**World Forum for Harmonization of Vehicle Regulations**

Working Party on Passive Safety

**Global technical regulation No. 9 (Pedestrian safety) – Phase 2  
of the global technical regulation  
(flexible legform impactor provisions)****Proposal for amendments to global technical regulation No. 9****Submitted by the expert from Japan\***

**Figure 13: FlexPLI; Dimensions and C.G. locations of femur, knee joint, and tibia (Side view)**

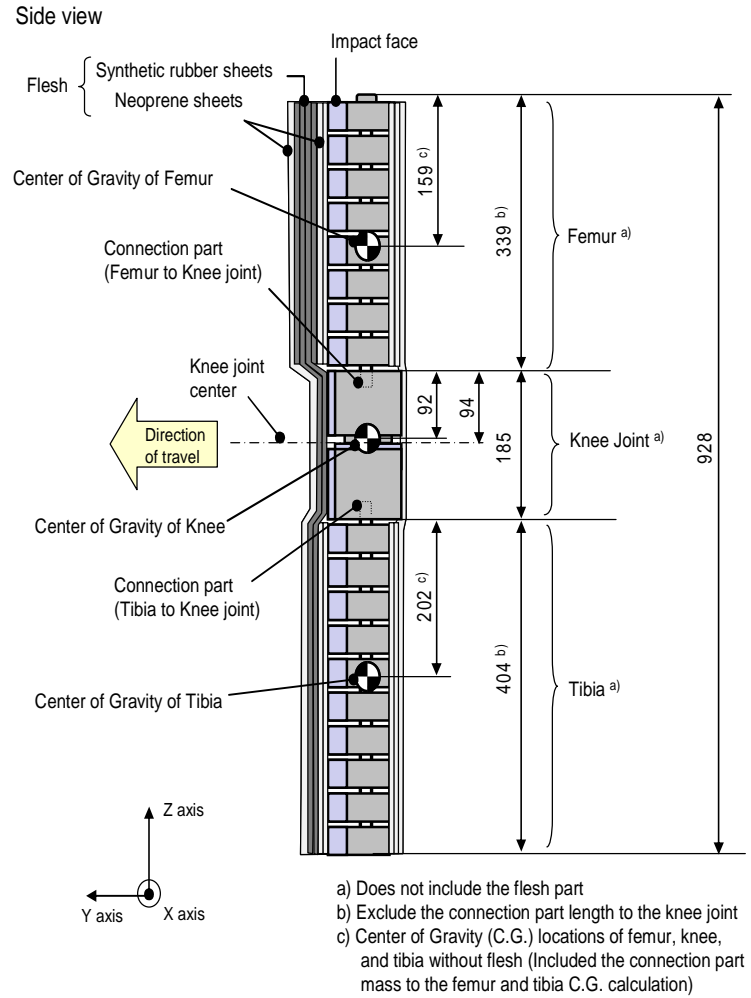
The lower legform impactor shall consist of flesh, flexible long bone segments (representing femur and tibia), and a knee joint as shown in Figure 13.

The overall length of the impactor shall be  $928 \pm 3$  mm, having a required mass of  $13.2 \pm 0.7$  kg including flesh. The length of the femur, knee joint, and tibia shall be  $339 \pm 2$  mm,  $185 \pm 1$  mm, and  $404 \pm 2$  mm respectively. The knee joint centre position shall be  $94 \pm 1$  mm from the top of the knee joint.

The centre of gravity of the femur and tibia without flesh, including the connection part to the knee joint, shall be  $159 \pm 8$  mm and  $202 \pm 10$  mm respectively from the top, but not including the connection part to the knee joint, of each part as shown in Figure 13. The centre of gravity of the knee shall be  $92 \pm 5$  mm from the top of the knee joint as shown in Figure 13.

Figure 14: FlexPLI; femur, tibia, and knee dimensions (Top view)

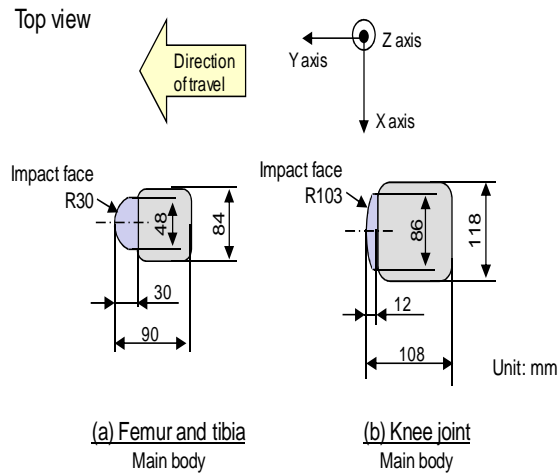
**6.3.1.2.1.** The cross-sectional shape perpendicular to the Z axis of the femur and tibia main bodies shall be  $90 \pm 2$  mm in width along the Y axis, and  $84 \pm 1$  mm in width along the X axis as shown in Figure 14 (a). The impact face shall be  $30 \pm 1$  mm in radius,  $30 \pm 1$  mm in width along the Y axis, and  $48 \pm 1$  mm in width along the X axis as shown in Figure 14 (a).

**6.3.1.2.2.** The cross-sectional shape perpendicular to the Z axis of the knee joint shall be  $108 \pm 2$  mm in width along the Y axis, and  $118 \pm 1$  mm in width along the X axis as shown in Figure 14 (b). The impact face shall be  $103 \pm 1$  mm in radius,  $12 \pm 1$  mm in width along the Y axis, and  $86 \pm 1$  mm in width along the X axis as shown in Figure 14 (b).

Figure 15: FlexPLI; flesh dimensions

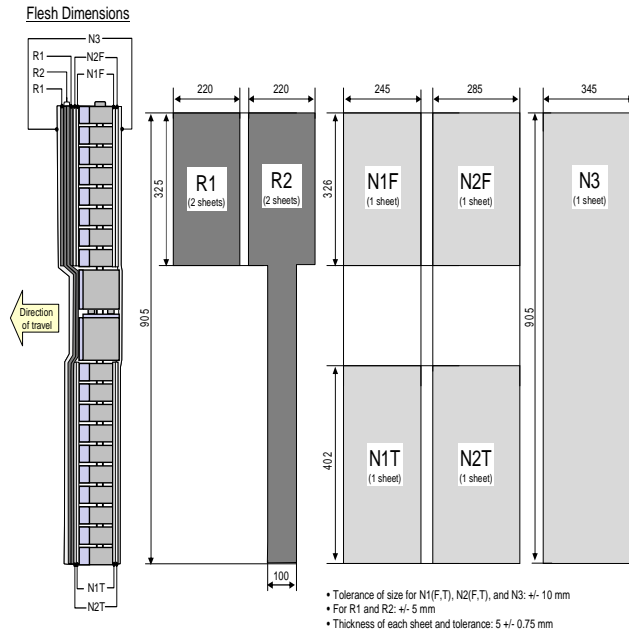
**6.3.1.2.4.** For each test, the impactor (femur, knee joint, and tibia) shall be covered by flesh composed of synthetic rubber sheets (R1, R2) and neoprene sheets (N1F, N2F, N1T, N2T, N3) as shown in Figure 15. The sheets are required to have a compression characteristic as shown in Figure 16. The compression characteristic shall be checked using the same batch of sheets as those used for the impactor flesh. The size of the sheets shall be within the requirements described in Figure 16.

**Figure 17: FlexPLI; instrument locations”**

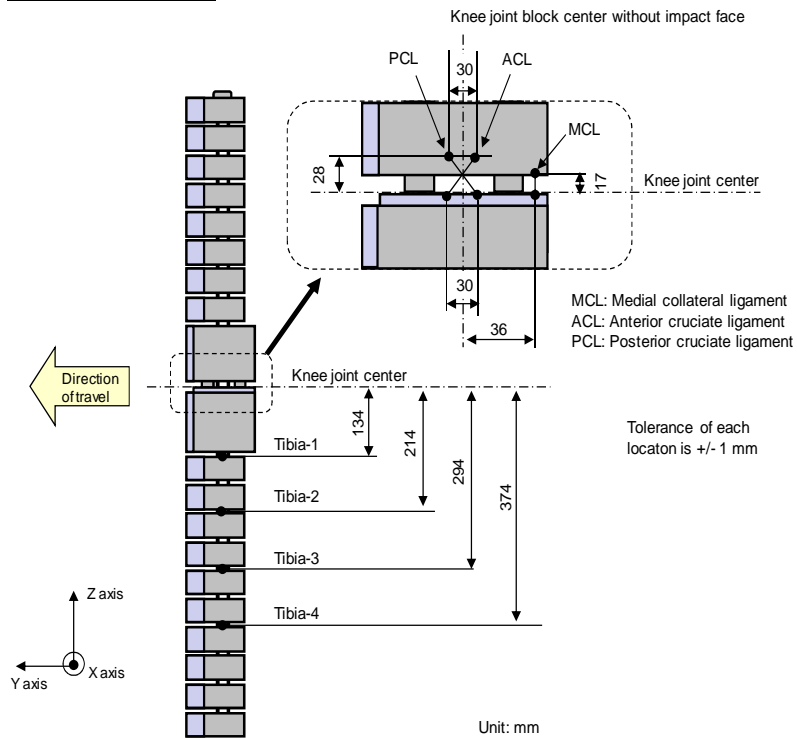
**6.3.1.2.6.1.** Four transducers shall be installed in the tibia to measure bending moments applied to the tibia. The sensing locations of each of the transducers are as follows: tibia-1:  $134 \pm 1$  mm, tibia-2:  $214 \pm 1$  mm, tibia-3:  $294 \pm 1$  mm, and tibia-4:  $374 \pm 1$  mm below the knee joint centre respectively as shown in Figure 17. The measurement axis of each transducer shall be the X axis of the impactor.

**6.3.1.2.6.2.** Three transducers shall be installed in the knee joint to measure elongations of the medial collateral ligament (MCL), anterior cruciate ligament (ACL), and posterior cruciate ligament (PCL). The measurement locations of each transducer are shown in Figure 17. The measurement locations shall be within  $\pm 3$  mm along the X axis from the knee joint centre.

Figure 23: Tolerances of angles for the lower legform impactor at the time of the first impact (see paragraphs 7.1.2.2. and 7.1.2.3.2.)

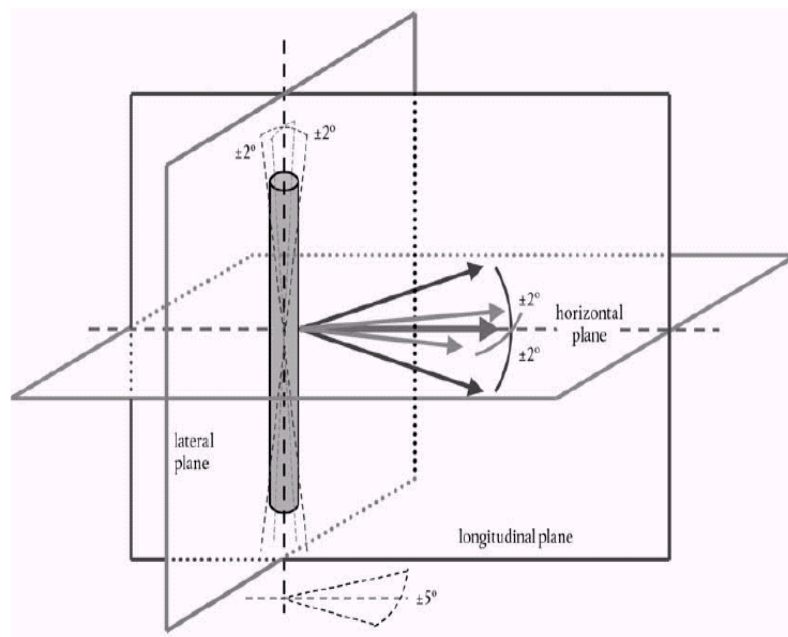
7.1.2.2. **The direction of the impact velocity vector shall be in the horizontal plane and parallel to the longitudinal vertical plane of the vehicle. The tolerance for the direction of the velocity vector in the horizontal plane and in the longitudinal plane shall be  $\pm 2^\circ$  at the time of first contact. The axis of the impactor shall be perpendicular to the horizontal plane, with a roll and pitch angle tolerance of  $\pm 2^\circ$  in the lateral and longitudinal plane. The horizontal, longitudinal and lateral planes are orthogonal to each other (see Figure 23).**

- 7.1.2.3.2. At the time of first contact the impactor shall have the intended orientation about its vertical axis, for the correct operation of its knee joint, with a yaw angle tolerance of  $\pm 5^\circ$  (see Figure 23).
- 7.1.2.3.3. At the time of first contact the centre line of the impactor shall be within a  $\pm 10$  mm tolerance to the selected impact location.
- 7.1.2.3.4. During contact between the impactor and the vehicle, the impactor shall not contact the ground or any object which is not part of the vehicle.
- 7.1.2.4. The impact velocity of the impactor when striking the bumper shall be  $11.1 \pm 0.2$  m/s. The effect of gravity shall be taken into account when the impact velocity is obtained from measurements taken before the time of first contact.”

**Figure 24: FlexPLI to bumper tests for complete vehicle in normal ride attitude (left) and for cut-body mounted on supports (right) (see paragraph 7.1.2.3.)**

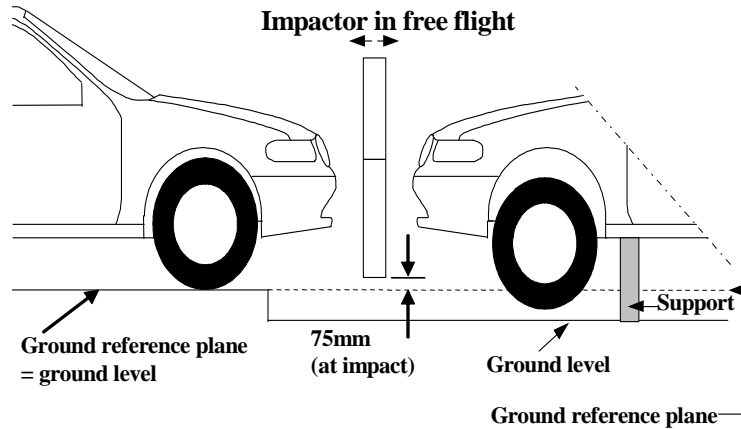
7.1.2.3. **The bottom of the impactor shall be at 75 mm above ground reference plane at the time of first contact with the bumper (see Figure 24), with a  $\pm 10$  mm tolerance. When setting the height of the propulsion system, an allowance must be made for the influence of gravity during the period of free flight of the impactor.**

Figure 31: Requirement corridor of femur and tibia in static certification test (see paragraph 8.2.1.2.)

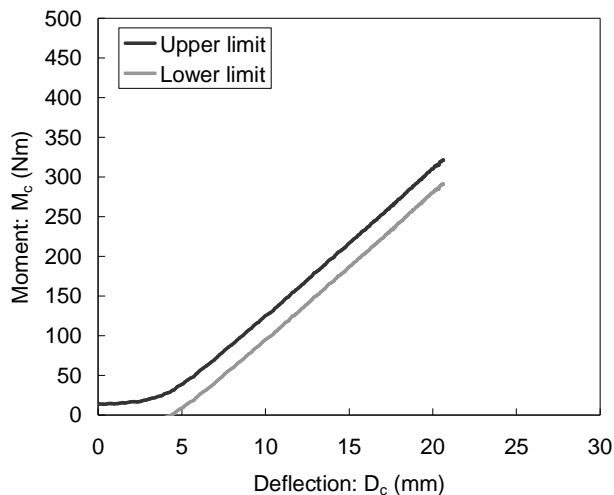
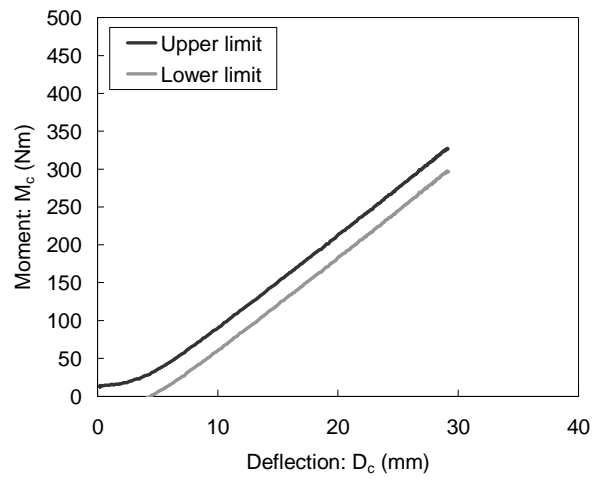
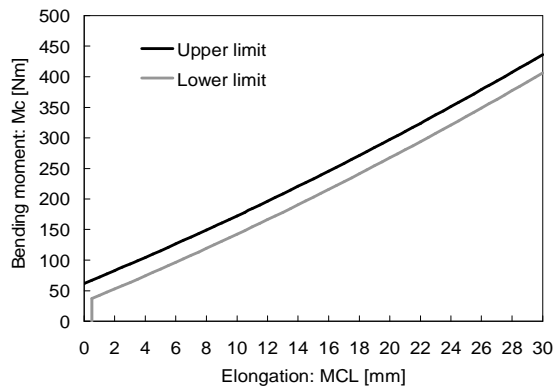
**8.2.1.2.        When the femur and tibia of the impactor are loaded in bending in accordance with paragraph 8.2.1.4., the applied moment and generated deflection at the centre of the femur and tibia ( $M_c$  and  $D_c$ ) shall be within the corridors shown in Figure 31.**

**Figure 32: Requirement corridors for knee joint in static certification test (see paragraph 8.2.1.3.)**

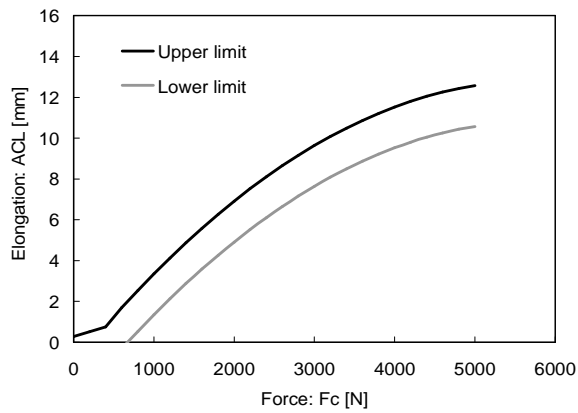
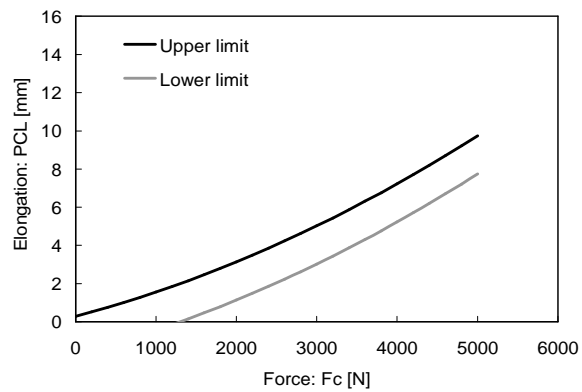
**8.2.1.3.        When the knee joint of the impactor is loaded in bending in accordance with paragraph 8.2.1.5., the MCL, ACL, and PCL elongations and applied bending moment or force at the centre of the knee joint ( $M_c$  or  $F_c$ ) shall be within the corridors shown in Figure 32.**

Figure 33: Test set-up for femur in static certification tests (see paragraph 8.2.1.4.)

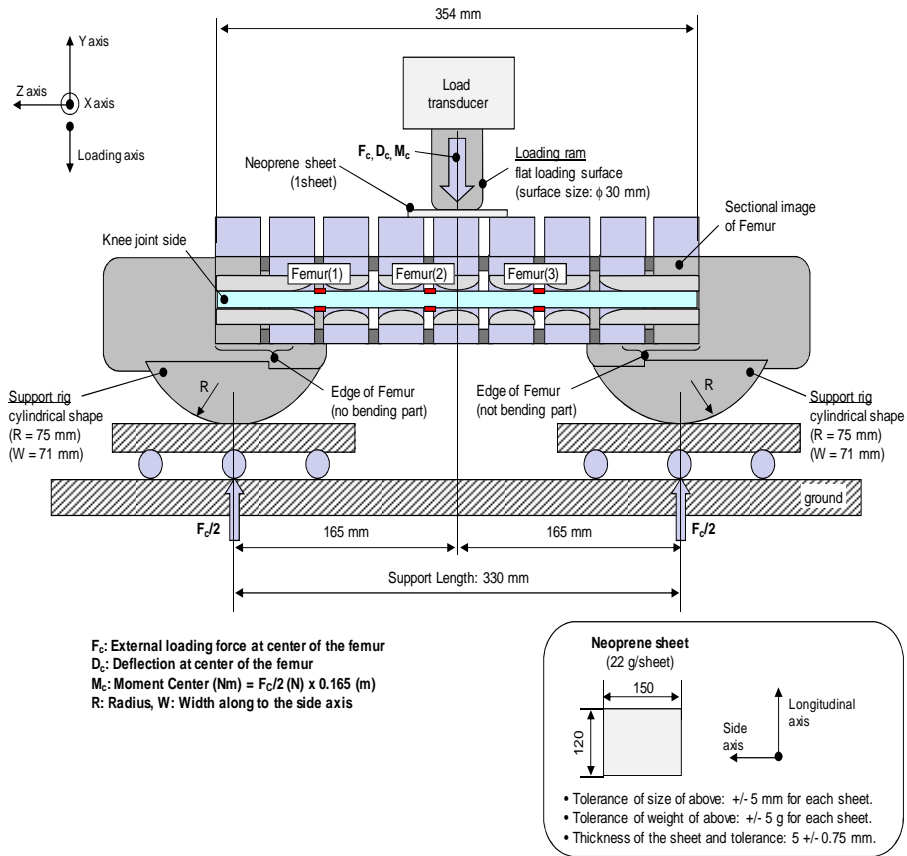
**8.2.1.4.        The edges of the femur and tibia, not bending parts, shall be mounted to the support rig firmly as shown in Figure 33. The Y axis of the impactor shall be parallel to the loading axis within  $180 \pm 2^{\circ}$  tolerance. In order to avoid friction errors, roller plates shall be set underneath the support rigs. To avoid impactor damage, a neoprene sheet shall be set underneath the loading ram. The neoprene sheet used in this test shall have compression characteristics as shown in Figure 16.**

Figure 34: Test set-up for tibia in static certification test (see paragraph 8.2.1.4.)

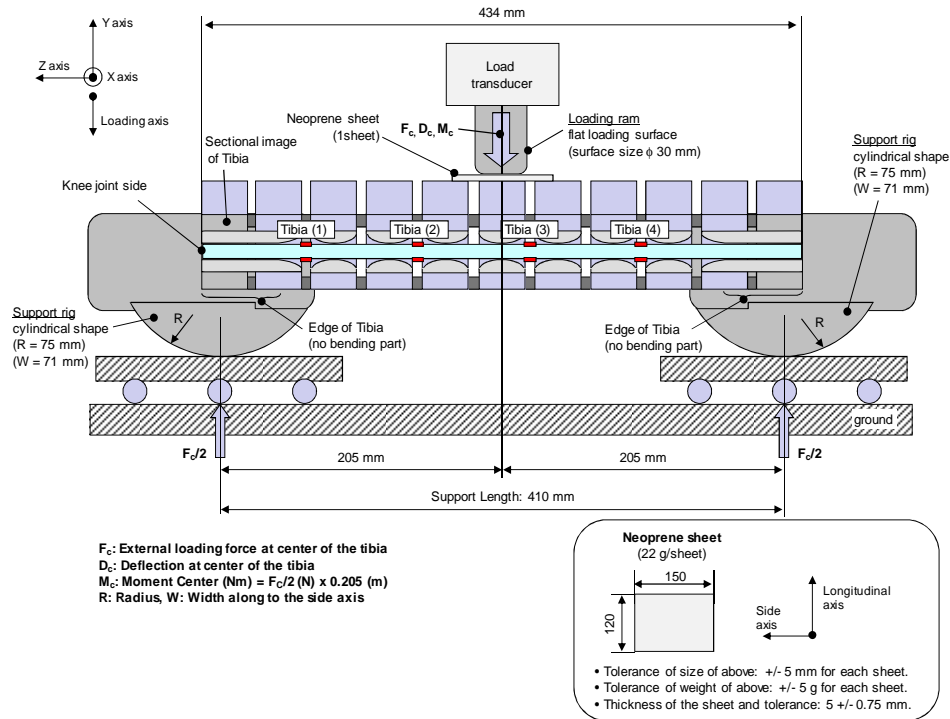
**The centre of the loading force shall be applied at the centre of the femur and tibia within  $\pm 2^{\circ}$  tolerance along the Z axis. The force shall be increased at a rate between 10 and 100 mm/minute until the bending moment at the centre part ( $M_c$ ) of the femur or tibia reaches [340] Nm.**

Figure 35: Test set-up for knee joint in static certification test (see paragraph 8.2.1.5.)

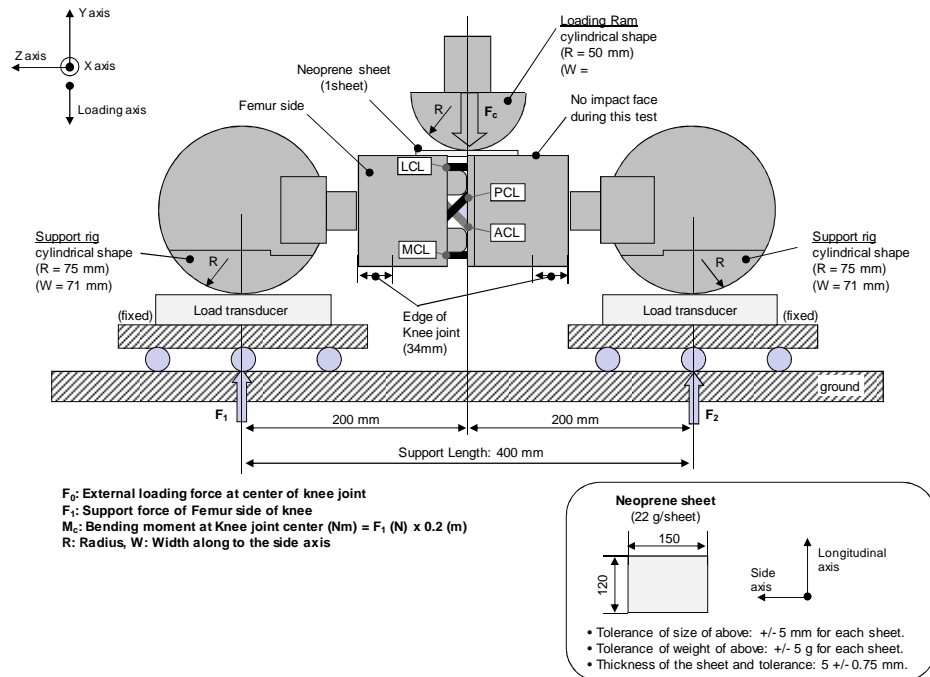
**8.2.1.5.        The edges of the knee joint, not bending parts, shall be mounted to the support rig firmly as shown in Figure 35. The Y axis of the impactor shall be parallel to the loading axis within  $180 \pm 2^{\circ}$ . In order to avoid friction errors, roller plates shall be set underneath the support rigs. To avoid impactor damage, a neoprene sheet shall be set underneath the loading ram and the impactor face of the knee joint which is described in the Figure 14 shall be removed. The neoprene sheet used in this test shall have compression characteristics as shown in Figure 16.**

**The centre of the loading force shall be applied at the centre of the knee joint within  $\pm 2^{\circ}$  tolerance along the Z axis. The external load shall be increased at a rate between 10 and 100 mm/minute until the bending moment at the centre part of the knee joint ( $M_c$ ) reaches 300 Nm.**

Figure 36: Test set-up for dynamic lower legform impactor certification test, Pendulum type (see paragraph 8.2.2.4.).

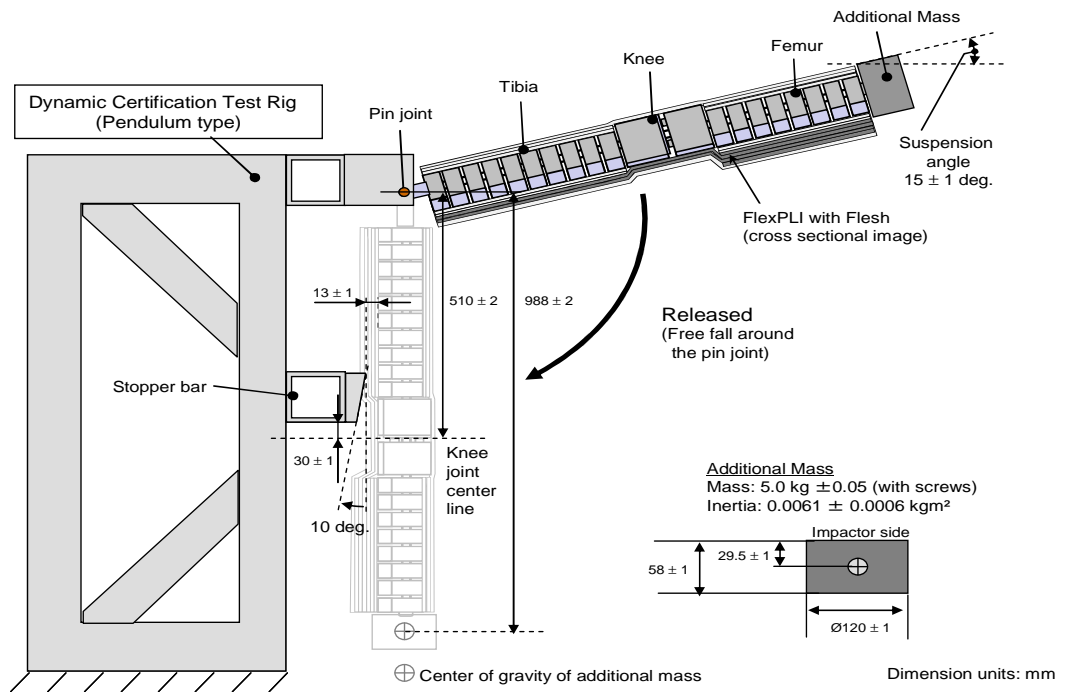
- 8.2.2.4. Test procedure
  - 8.2.2.4.1. The impactor, including flesh, shall be suspended from the dynamic certification test rig  $15 \pm 1^\circ$  upward from the horizontal as shown in Figure 36. The impactor shall be released from the suspended position, whereupon the impactor falls freely against the pin joint of the test rig as shown in Figure 36.

- 8.2.2.4.2. The knee joint centre of the impactor shall be  $30 \pm 1$  mm below the bottom line of the stopper bar, and the tibia impact face shall be located  $13 \pm 1$  mm from the front upper edge of the stopper bar when the stopper block is removed from the stopper bar and then hung from the impactor without any contact (see Figure 36).

Figure 37: Test set-up for dynamic lower legform impactor certification test, Inverse type (see paragraph 8.2.3.4.).”

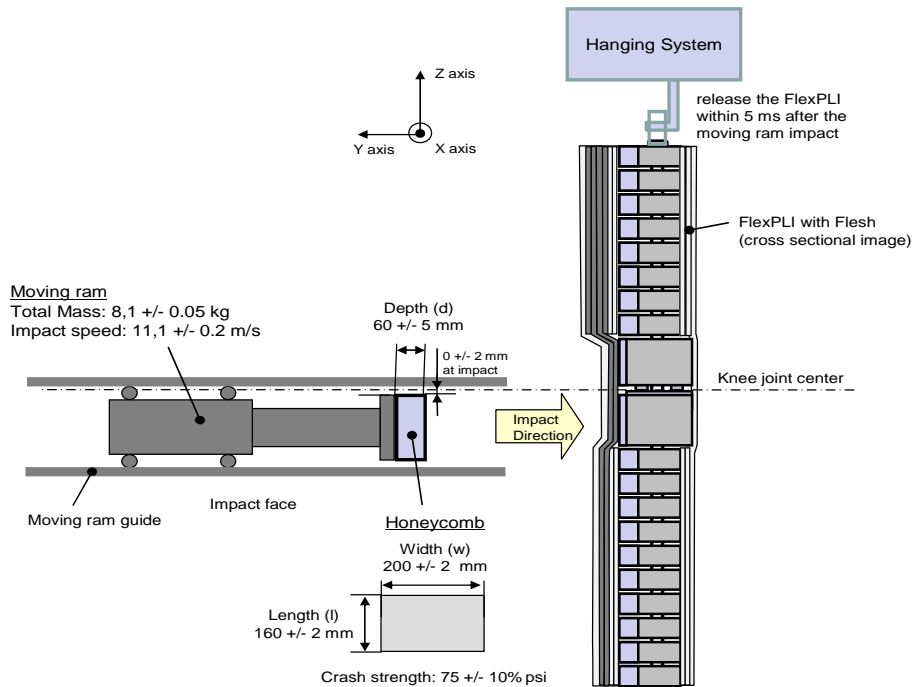
- 8.2.3.4. Test procedure
- 8.2.3.4.1. The fully assembled FlexPLI (with flesh and skin) shall be stationary suspended vertically from a test rig as shown in Figure 37. It is then impacted by the upper edge of a linearly guided Al honeycomb impactor, covered by a thin (less than 1 mm thickness) paper cloth, at an impact speed of  $11,1 \pm 0,2$  m/s. The legform is to be released from the test rig within 5 ms after the time of first contact to ensure a free flight condition.

- 8.2.3.4.2. The honeycomb of 5052 alloy, which is attached in front of the moving ram, shall have a crash strength of  $75 \pm 10$  per cent psi and dimensions of  $l=200 \pm 2$  mm,  $w = 160 \pm 2$  mm and  $d = 60 \pm 5$  mm. To ensure a consistent and good level of repeatability, the honeycomb should either have a 3/16 inches cell size in combination with a density of 3.1 pcf or a 1/4 inches cell size in combination with a density of 2.3 pcf or a 3/16 inches cell size in combination with a density of 2.0 pcf.

- 8.2.3.4.3. The upper edge of the honeycomb face is to be in line with the rigid plate of the linearly guided impactor. At time of first contact, the upper edge of the honeycomb is to be in line with the knee joint centre line within a vertical tolerance of  $0 \pm 2$  mm. The honeycomb shall not be excessively handled or deformed before the impact test.
